Project	<b>IEEE 802.16 Broadband Wireless Access Working Group</b> < <a href="http://ieee802.org/16">http://ieee802.org/16</a> >	
Title	<b>Mobility of transparent RS</b>	
Date Submitted	<b>2007-04-06</b>	
Source(s)	<p>Kaibin Zhang, Gang Shen, Jimin Liu, Shan Jin Alcatel-Lucent, Research &amp; Innovation 388#, Ningqiao Road, Shanghai, P. R. China</p> <p>Fang-Ching Ren, Chie-Ming Chou, Kun-Ying Hsieh ITRI, TAIWAN</p> <p>D.H. Ahn, Junhong Hui, Young-il Kim, C.I.Yeh ETRI 161, Gajeong-Dong, Yuseong-Gu, Daejeon, 305-350, Korea</p> <p>Fang Liu, Lan Chen, Xiaoming She, Daqing Gu DoCoMo Beijing Lab 7/F, Raycom Infotech Pack Tower A No.2 Kexueyuan South Rd., Haidian District, Beijing, China</p> <p>Fujio Watanabe DoCoMo USA Labs 240 Hillview Avenue, Palo Alto, CA</p>	<p>Voice: 86-21-50551240-8194 Fax: 86-21-50554554 Email: <a href="mailto:kaibin.zhang@alcatel-sbell.com.cn">kaibin.zhang@alcatel-sbell.com.cn</a></p> <p>Email: <a href="mailto:frank_ren@itri.org.tw">frank_ren@itri.org.tw</a></p> <p>Email: <a href="mailto:dhahn@etri.re.kr">dhahn@etri.re.kr</a></p> <p>Voice: +86-10-82861501 ex.331 Fax: +86-10-82861506 <a href="mailto:{liu, gu}@docomolabs-beijing.com.cn">mailto:{liu, gu}@docomolabs-

Figure 2 Procedures of transparent MRS handover

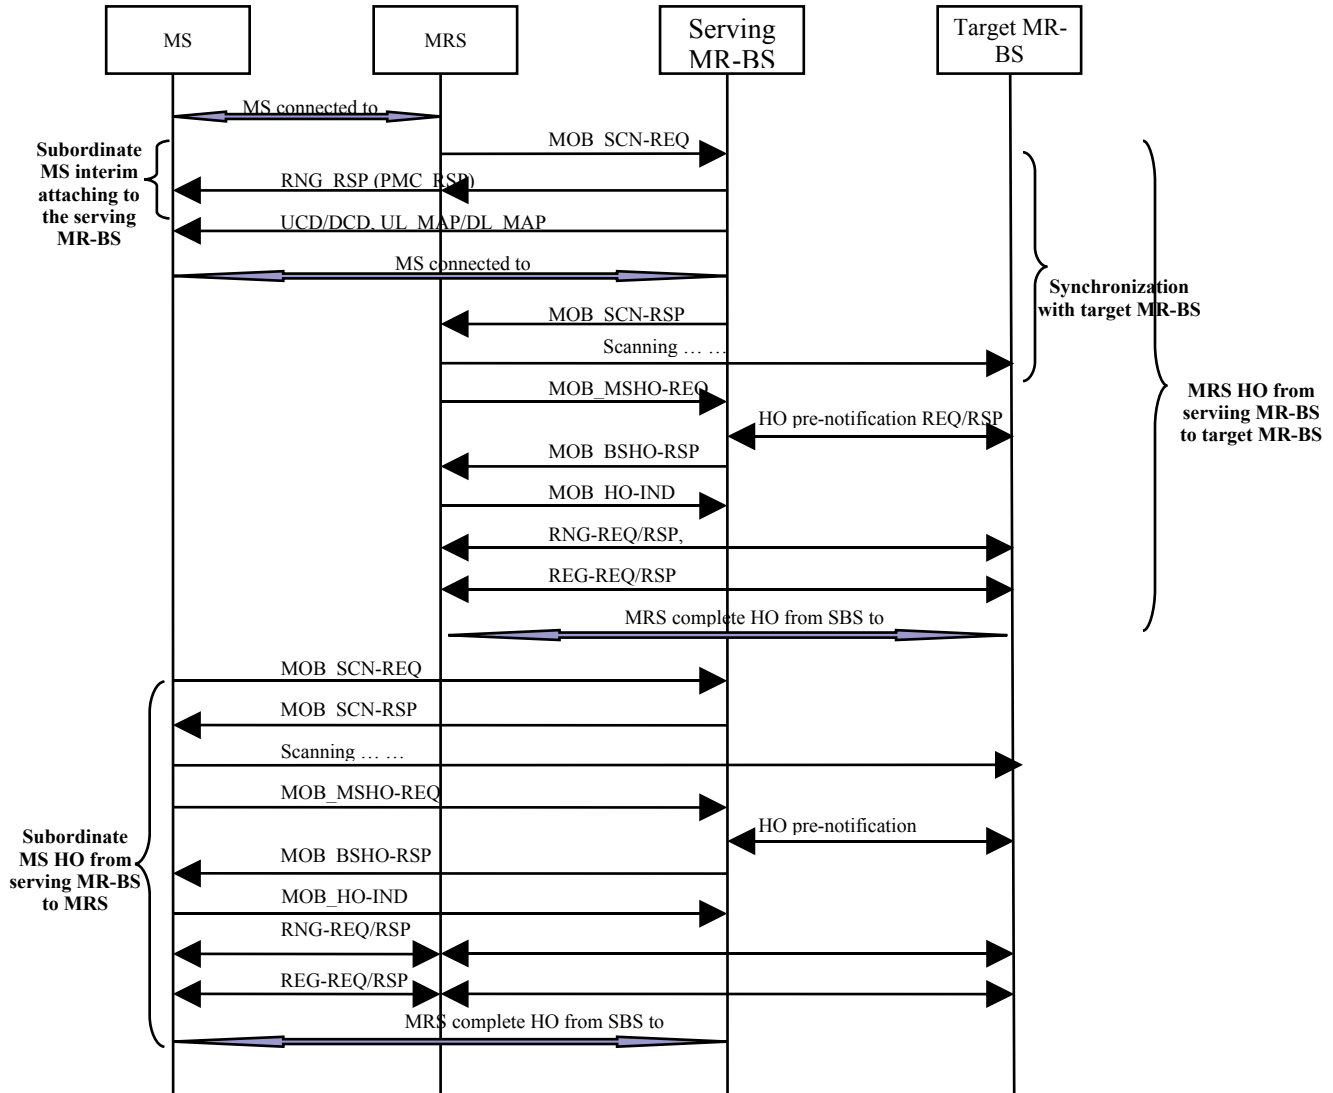
*[Insert the new subclause 6.3.22.4]*

[The subclause defines the transparent MRS HO process in which a transparent MRS with its attached MSs migrates from the air-interface provided by the serving access station to the air-interface provided by the target access station. Unless otherwise indicated in this subclause, MRS HO process is processed according to MS handover process defined in 6.3.22.2.](#)

[In order to maintain the service continuity of the MSs associated to the MRS when the MRS is performing scan of potential target access station or other HO procedures, the serving MR-BS shall conduct the MSs associated to MRS to attach to the MR-BS or other neighboring access station. Once the MRS HO process complete, the MSs originally associated to the MRS shall performs the process defined in 6.3.22.2 to handover from the serving MR-BS to the MRS.](#)
